This is what I think was suggested. I do not see this being a great idea, although I have never tried this.

Feedback #2

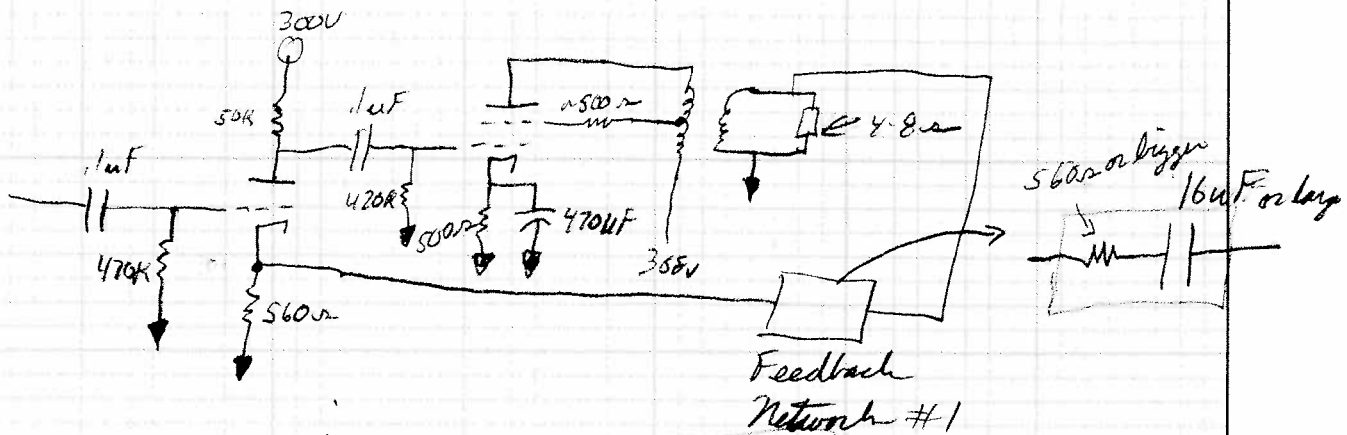
wouldn't this be better on the 6V6?

12AT7 or 6V6?
